**RE: Priest Rapids Hydroelectric Project No. 2114-217
License Compliance Filing – Article 411 Transmission Line Avian Collision
Protection Plan 2012 Annual Report**

Priest Rapids Project – FERC No. 2114
Transmission Line Collision Protection Plan
2012 Annual Report
License Article 411

Appendix B
Agency Comments

Figure 3 The three-span transmission line cluster at Midway with Midway – Frenchman Hills 230kV line between Structures #681 and #682 and Priest Rapids – Midway 230kV Line #2 between Structures #144 and #145 identified.

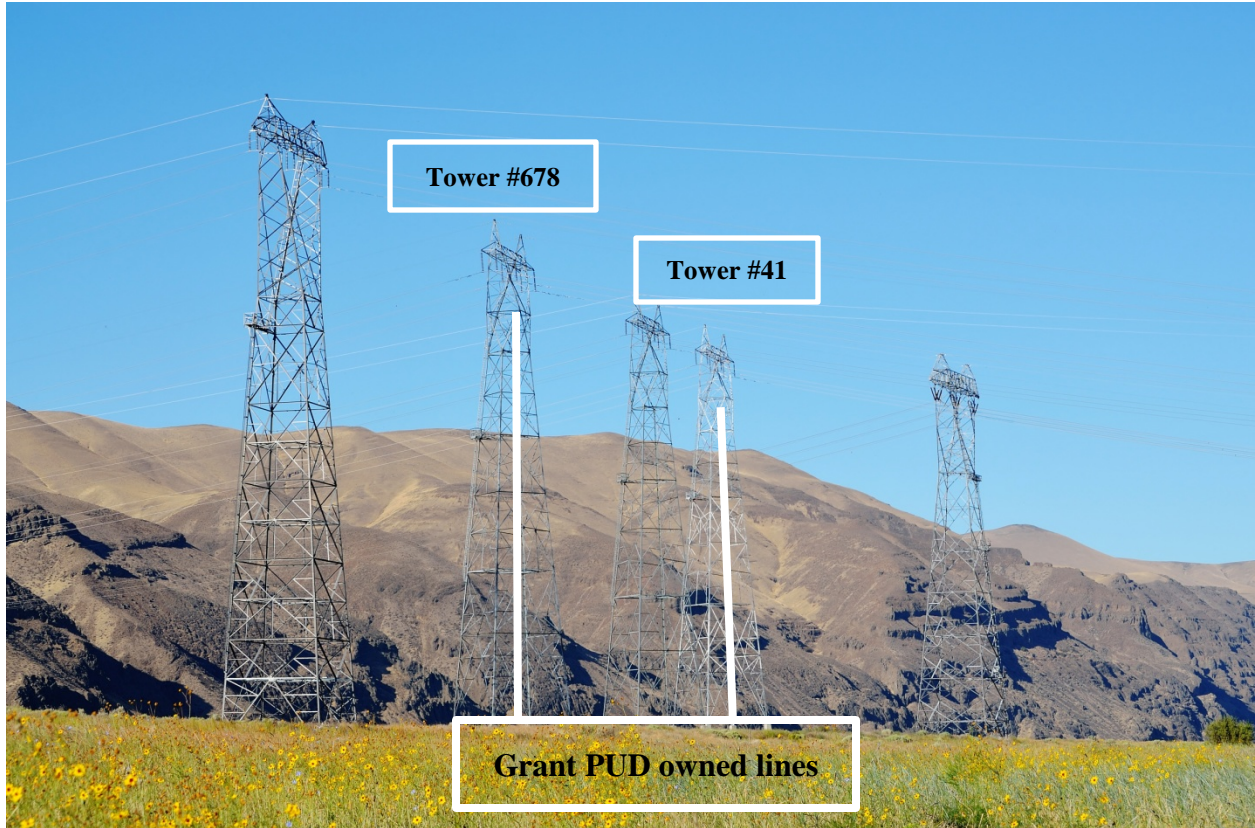
- Figure 3 is a bit confusing and it's likely due to my ignorance of not seeing these transmission line configurations out in the field. However, this figure appears to suggest that Tower #144 is on the outside of this particular configuration, perhaps warranting BFD's? I know the figure resolution is a bit obscure, but the BPA appears not to have BFD's as well? Some clarity in reference to this figure would be helpful.

Submitting Entity	Date Received	Paragraph #	Agency Comment	Grant PUD Response
USFWS	03/26/2013	4	Figure 3 is a bit confusing and it's likely due to my ignorance of not seeing these transmission line configurations out in the field. However, this figure appears to suggest that Tower #144 is on the outside of this particular configuration, perhaps warranting BFD's? I know the figure resolution is a bit obscure, but the BPA appears not to have BFD's as well? Some clarity in reference to this figure would be helpful.	Grant PUD understands the confusion, and agrees that is hard to determine the three-dimensional depth in a two-dimensional photograph without site knowledge. Tower #144 is on the outside of this configuration, and yes, Grant PUD plans to install BFD on the span with Tower #144. Grant PUD has also modified "Section 4.0 Adaptive Management – Midway Spans" to enhance the clarification.
